# County of Fresno

Contract No. 23-29-C

**ADDENDUM NO. 1** to CSA 1 TAMARACK WATER INFRASTRUCTURE REPLACEMENT, revising the Bidding and Contract Documents as follows:

DRAWING NO. 11334 SHEET NO. 18A TOTAL 23

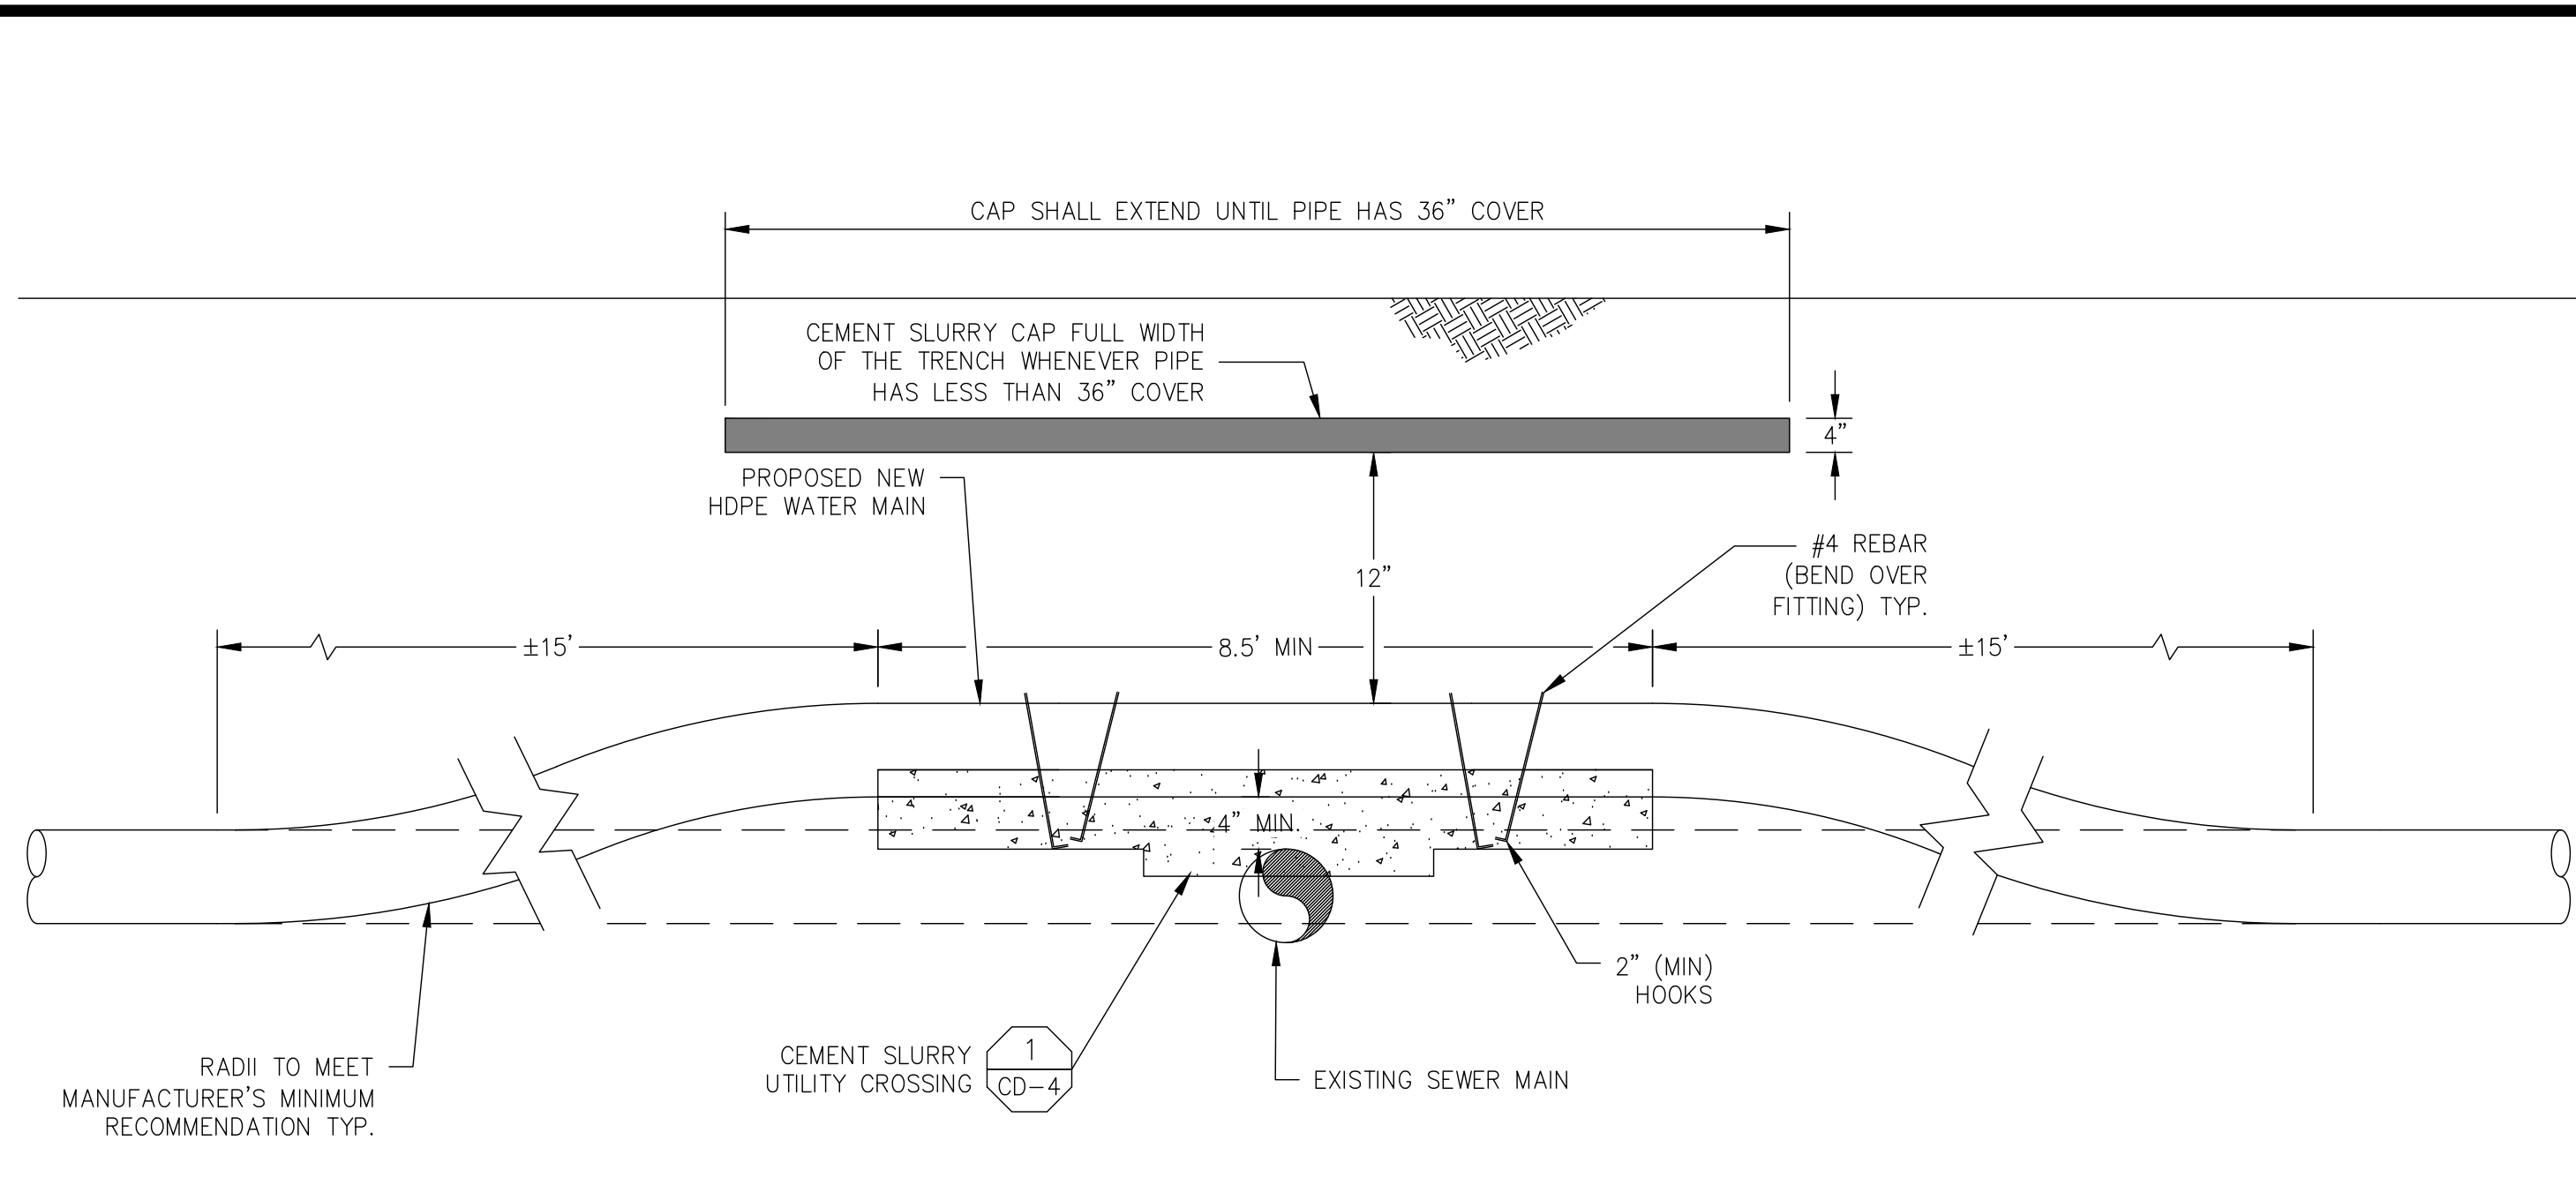
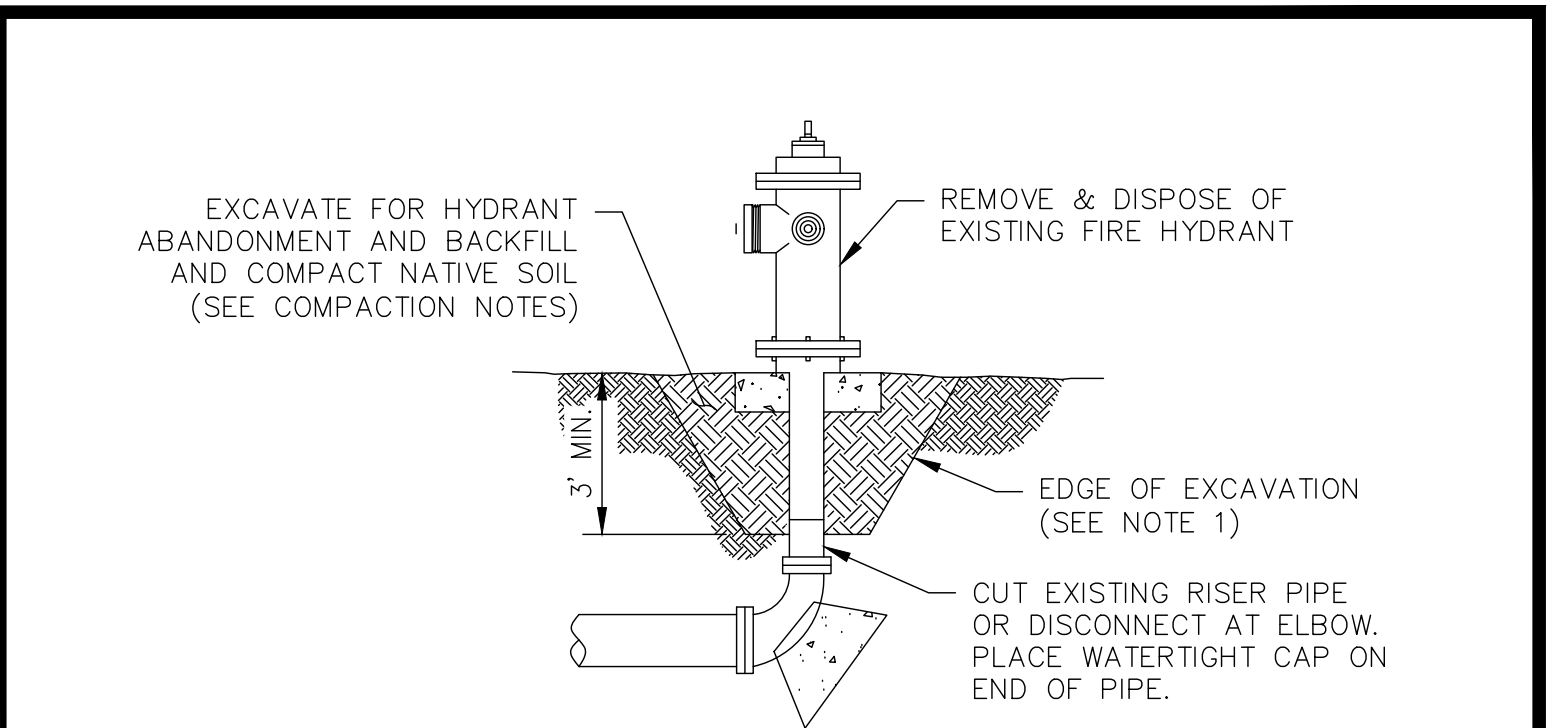
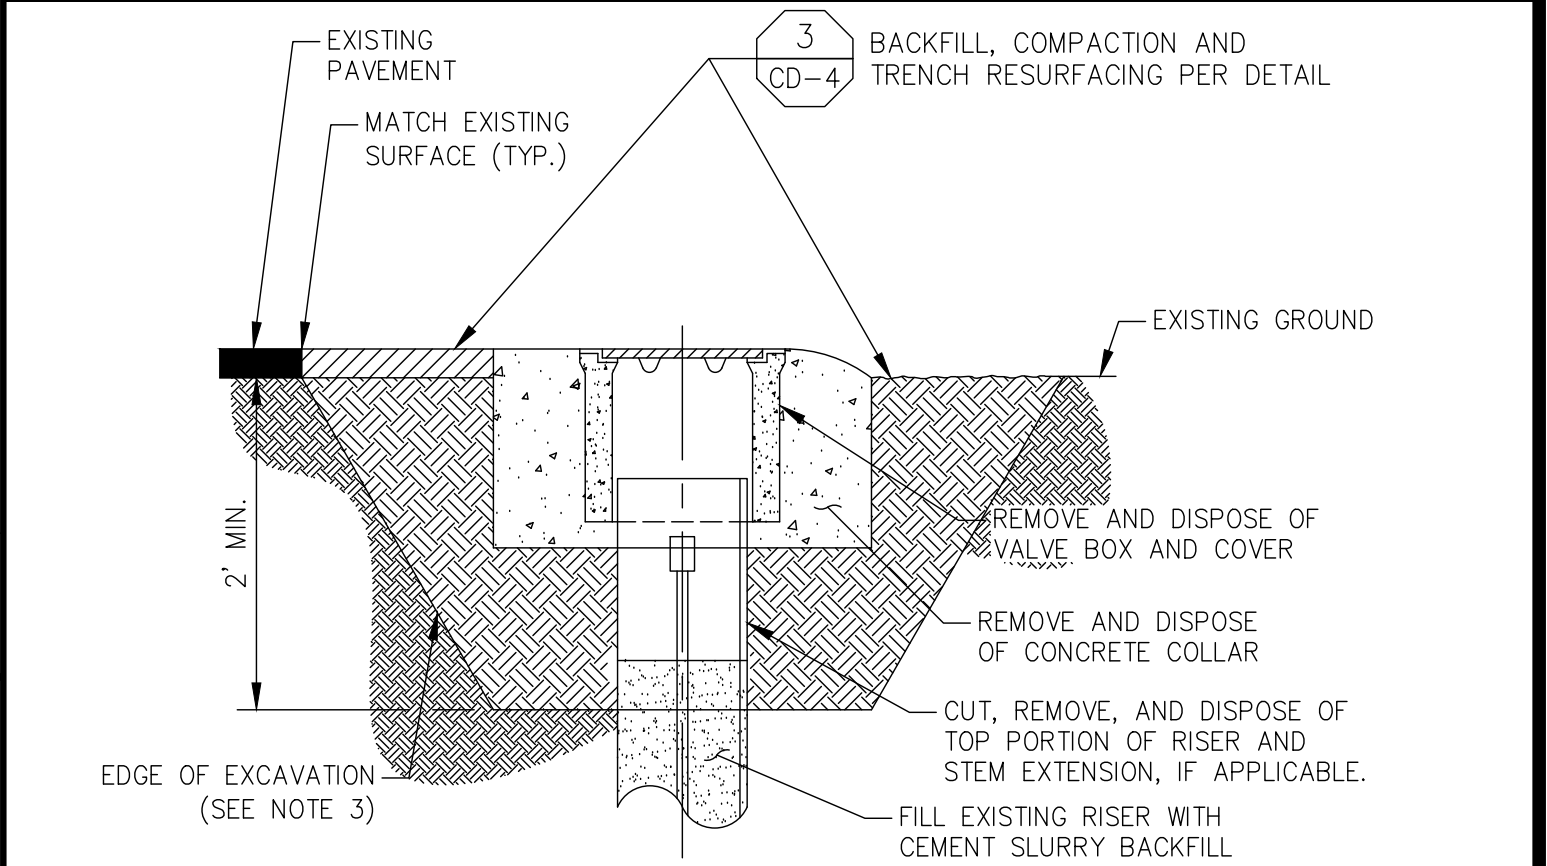
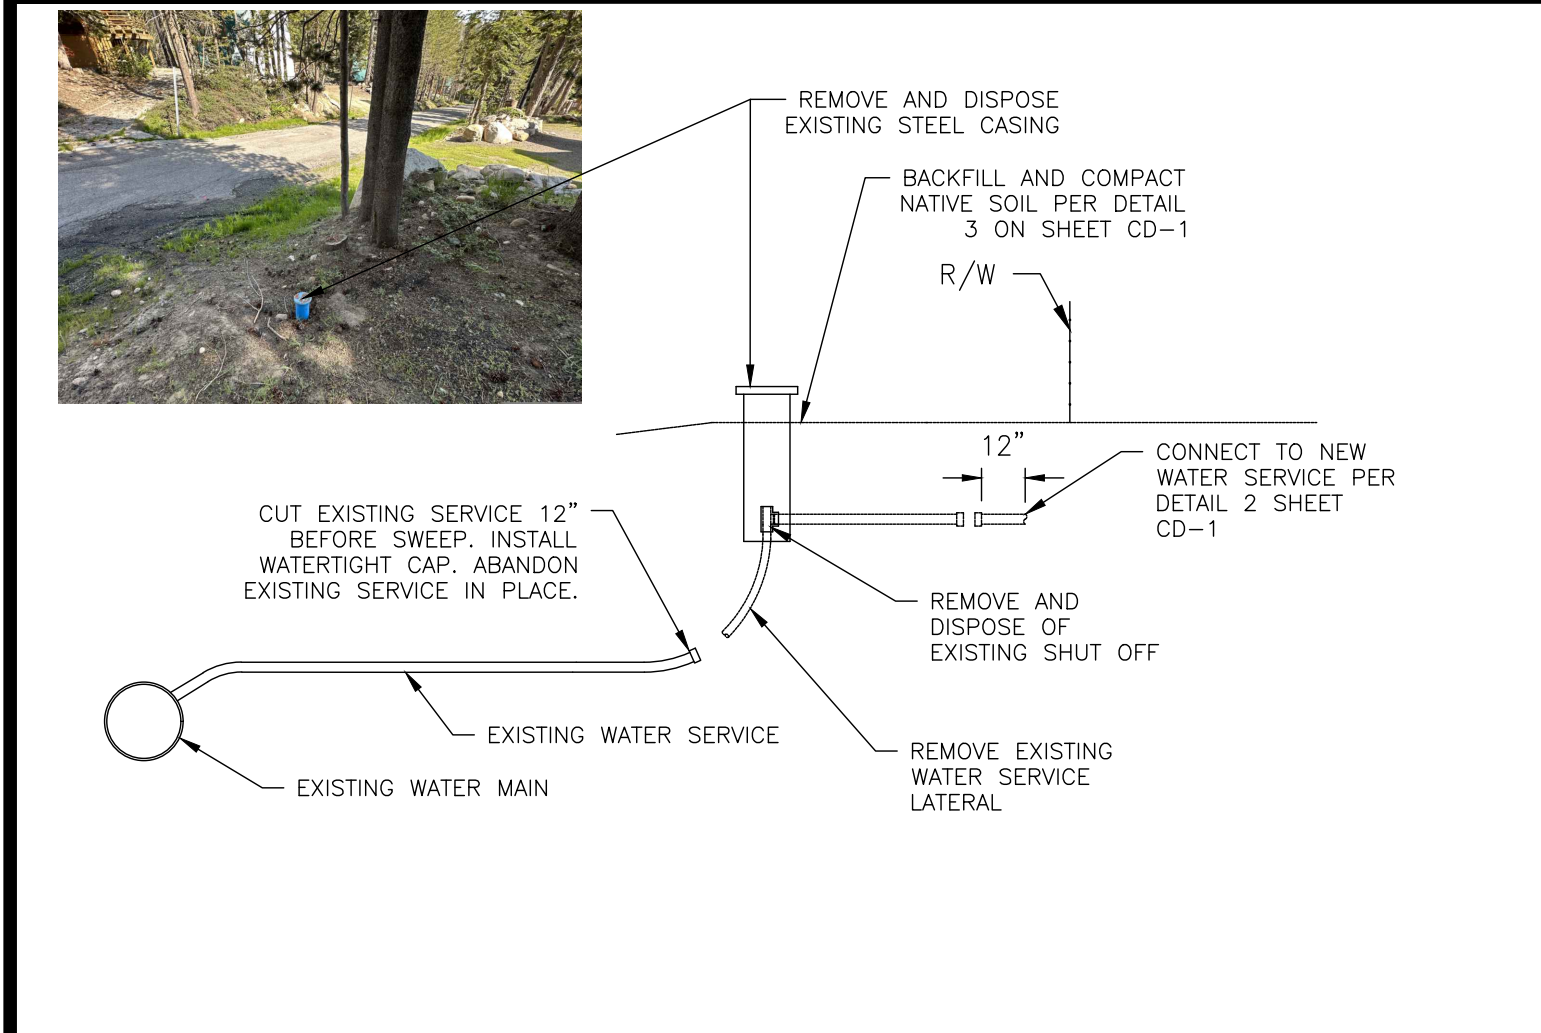
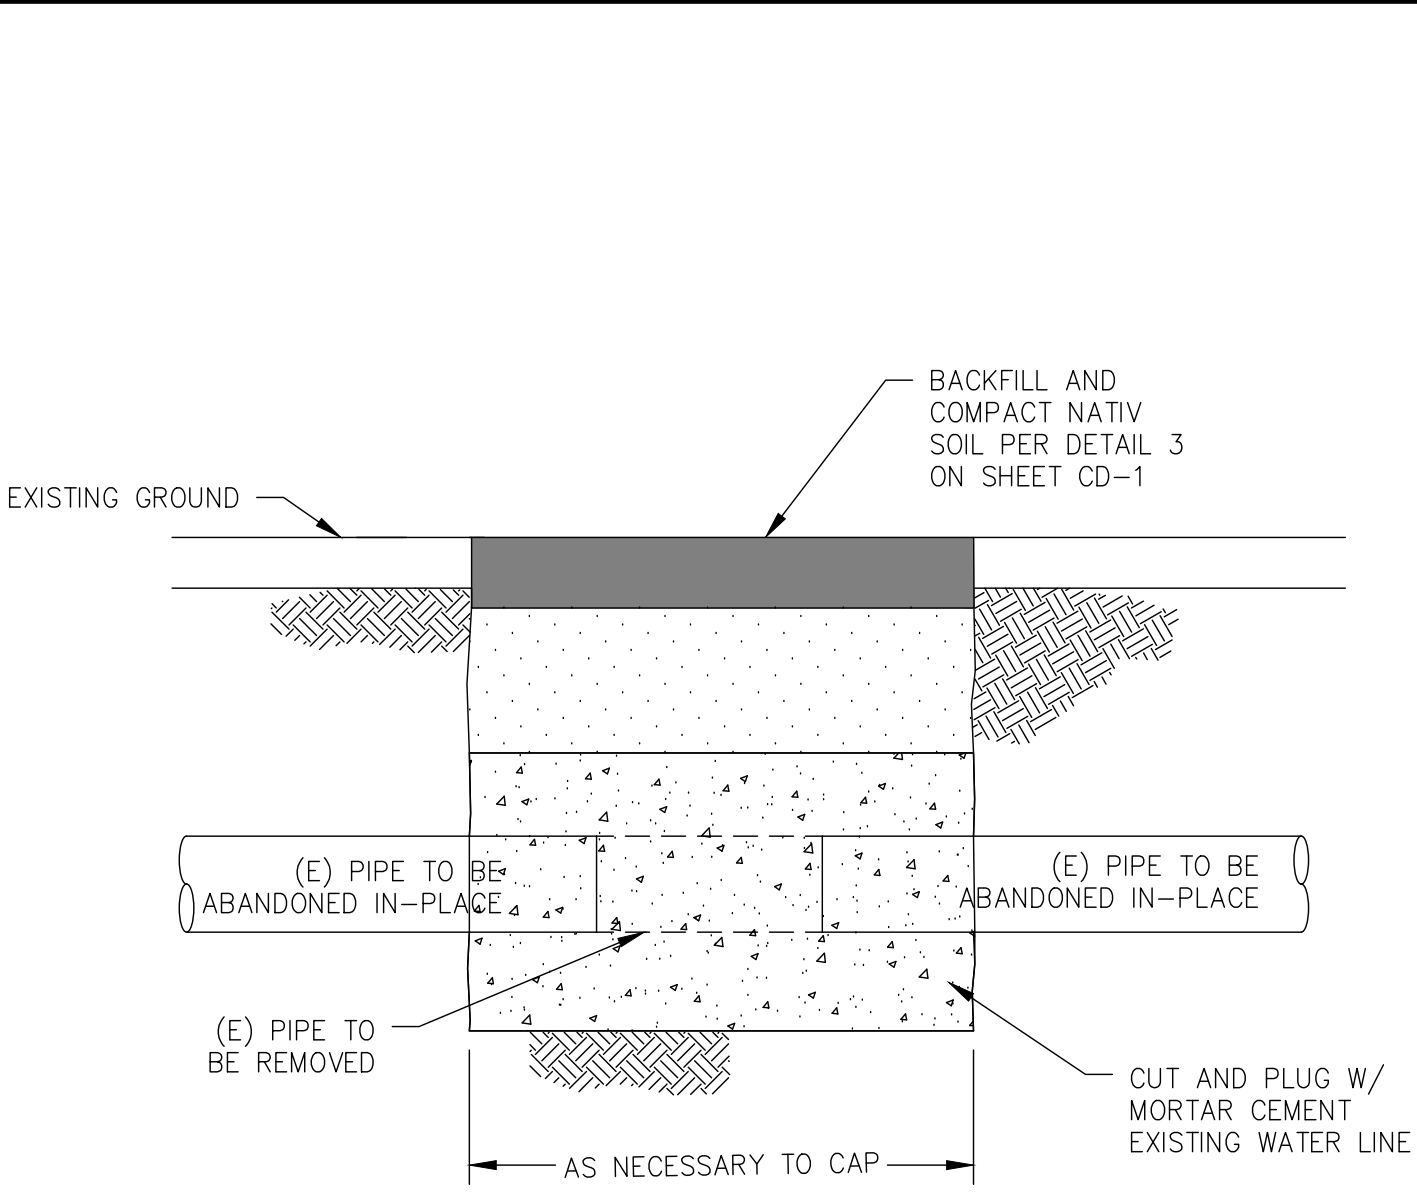
Changes to the following pages are denoted by a revision cloud.

Construction plan Sheet 18A

Construction plan Sheet 21
